PCN#20230322001.1 Qualification of new Fab site (RFAB) using qualified Process Technology, Die Revision, and datasheet for select devices

Change Notification / Sample Request

Date: March 23, 2023 **To:** TOKYO ELECTRON DEVICE (DSTR) PCN

Sample product shipping label (not actual product label)

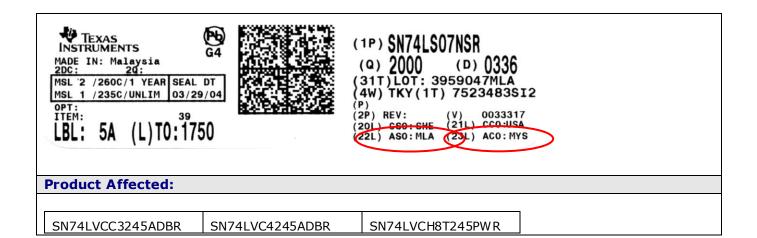
Changes to product identification resulting from this PCN:

Chip Site	Chip Site Origin Code (20L)	Chip Site Country Code (21L)	Chip Site City
FR-BIP-1	TID	DEU	Freising
RFAB	RFB	USA	Richardson

Current	New		
Die Rev [2P]	Die Rev [2P]		
-,B	Α
